CERTIFICATE OF APPROPRIATENESS

Property: 1710 Crockett St, Lot 3, Block 229, Baker NSBB Subdivision. The property includes a historic 1,142 square foot, one-story wood frame single-family residence situated on a 5,000 square foot (50' x 100') interior lot.

Proposal: Alteration – Windows/Porch

WEST SIDE ELEVATION

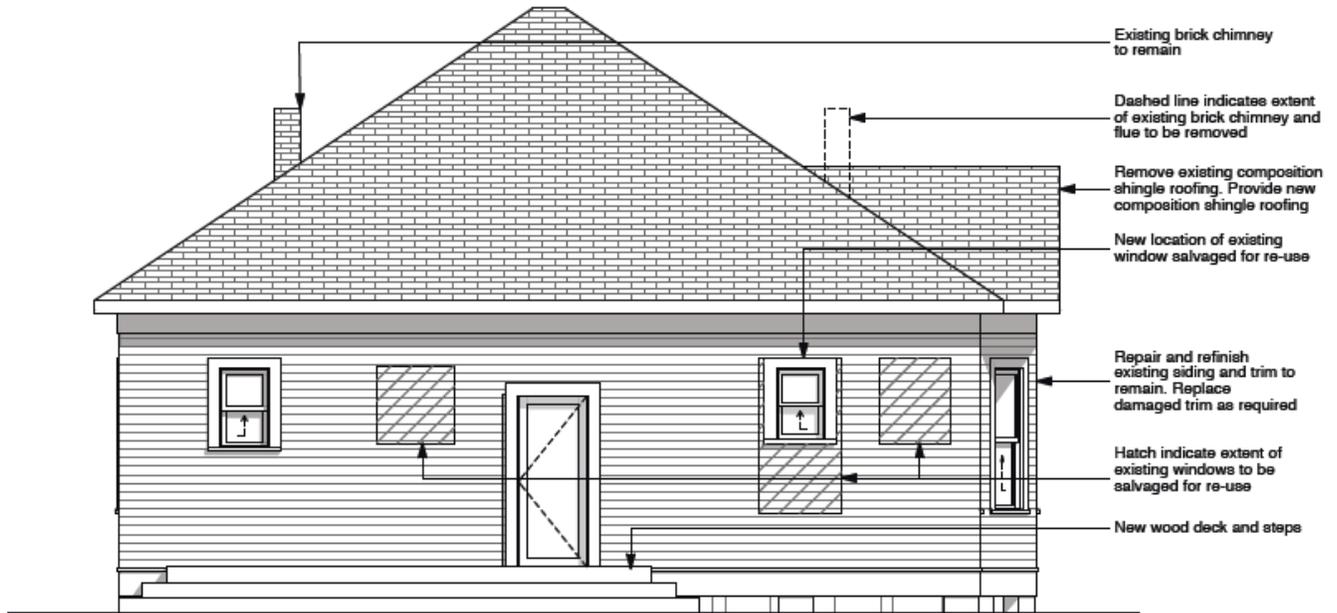
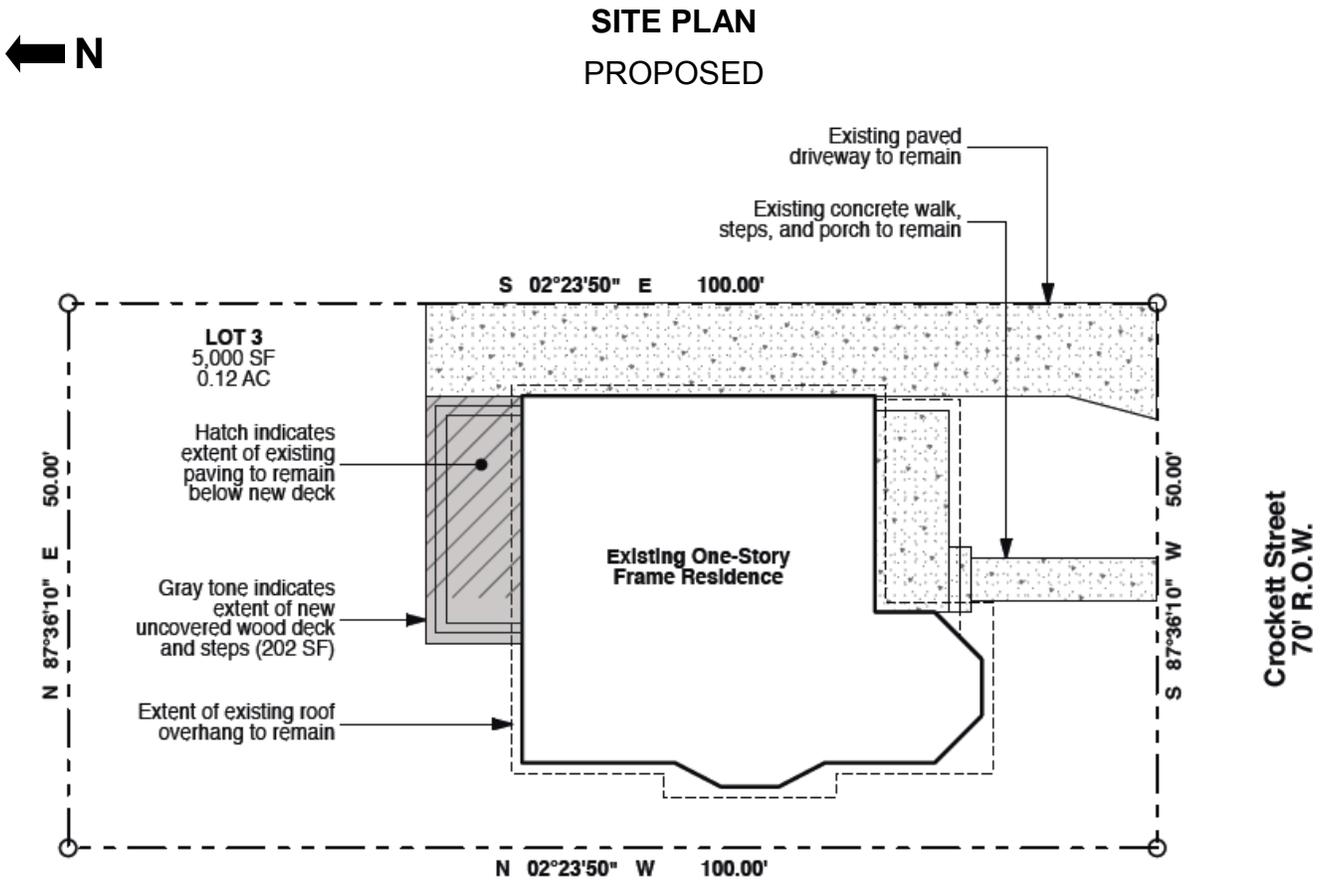
<i>Windows are key elements of the property's historical character and should be retained. Altering the original fenestration pattern diminishes the character of the property and should not be altered on the basis of an interior remodel.</i> |

<i>The relocation of the window from its existing location destroys historic material through the removal of siding. The relocation also involves the unnecessary installation of new siding at the existing window's location. Relocating the window may also cause structural issues unforeseen at this time and cause the further alteration of the west elevation.</i> |

Recommendation: Partial Approval: Approval for replacement of porch columns/rails and removal of damaged rear chimney, denial for relocation of window

HAHC Action: Approved with Conditions: Use salvaged wood siding to close the original location of the relocated window.
